UNITED STATES PATENT AND TRADEMARK OFFICE

APPLICATION NO.	FILING DATE	FIRST NAMED INVENTOR	ATTORNEY DOCKET NO.	CONFIRMATION NO.
10/655,715	09/06/2003	Robert W. Holland	KLW 001 P2	8790
7590	10/05/2005		EXAMINER	
Patrick P. Phillips Kremblas, Foster, Phillips & Pollick 7632 Slate Ridge Boulevard Reynoldsburg, OH 43068			POPOVICS, ROBERT J	
			ART UNIT	PAPER NUMBER
			1724

Office Action Summary	Application No.	Applicant(s)
	10/655,715	HOLLAND ET AL.
Examiner	Art Unit	
Robert J. Popovics	1724

DETAILED ACTION

FIG. 2

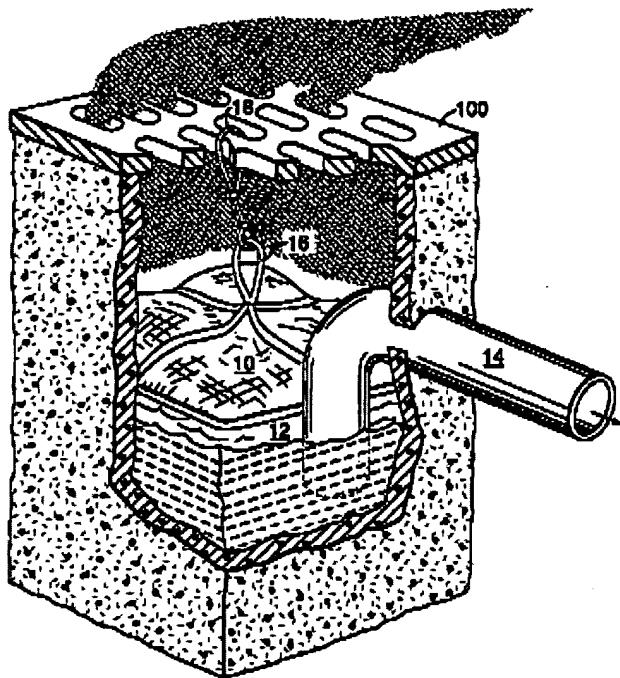
Claims 1-2 and 5-7 are rejected under 35 U.S.C. 102(b) as being anticipated by **Morris** (US 6,099,723). See Figure Two and column 3, line 2.
